CPW Comments Bernhardt Sand and Gravel Pit Project

Thank you for including CPW in the Bernhardt Sand and Gravel Pit Project review process.

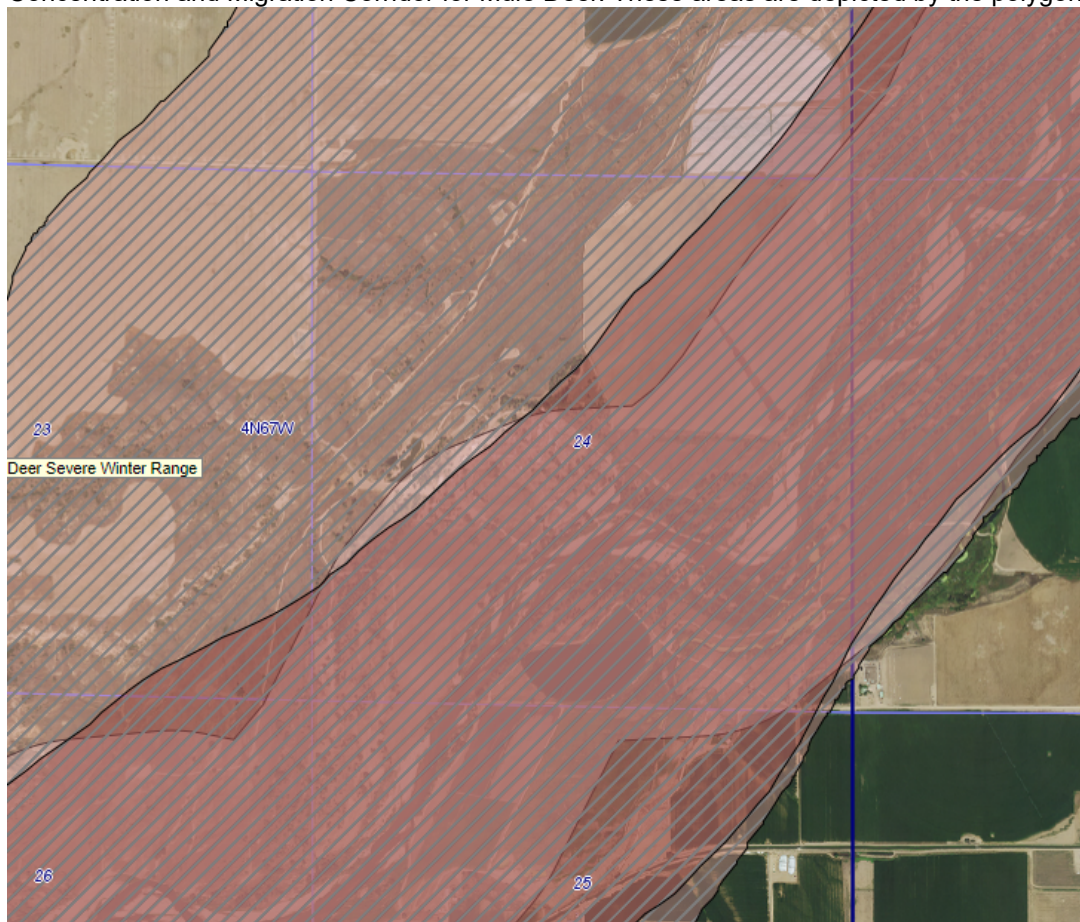
Mule Deer Severe Winter Ranges are defined as that part of the overall winter range where 90% of the individuals are located when the annual snowpack is at its maximum and/or temperatures are at a minimum in the two worst winters out of ten. **Therefore, CPW recommends no initial ground disturbance in these polygons from December 1 to April 30. CPW also recommends maintaining the riparian corridor to the maximum extent possible to keep the migration corridor along the river as open as possible.** Below is a mapped HPH layer for the Severe Winter Range, Winter Concentration and Migration Corridor for Mule Deer. These areas are depicted by the polygons with pink-striped areas.
